Ref: Council Response EX15

Church Cliff Drive, Filey – SiteHA23 (Flooding Information).

1. Response to SBC Ref: EX15 – Site HA23 Flooding Information

SBC and Royal Haskonig DHV. Page 21, How it works – North Area – With Scheme.

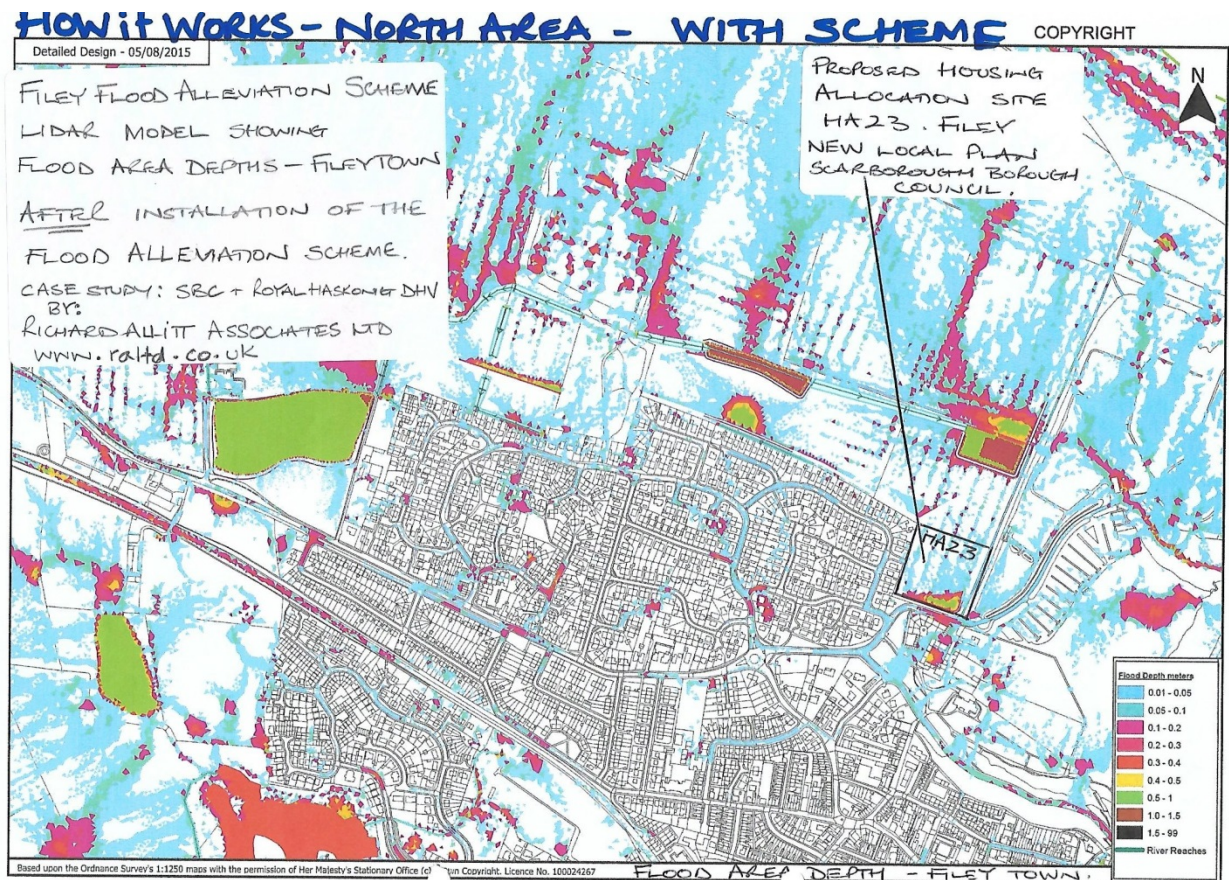
Even with the Filey Flood Alleviation Scheme in place, the southern end of HA23 will be exposed to flood protection flood water storage/ ponding⁹. So development will incur costs of a storm water attenuation system, which links to the viability of the development.

Due to the technical design of the Filey Flood Alleviation Scheme the residential areas around site HA23 will be fully protected from potential flooding. However, according to the Lidar Model¹¹ submitted it is clear that HA23 will be subject to flood protection flood water storage/ ponding and will therefore still remain classified as a flood zone 3b.
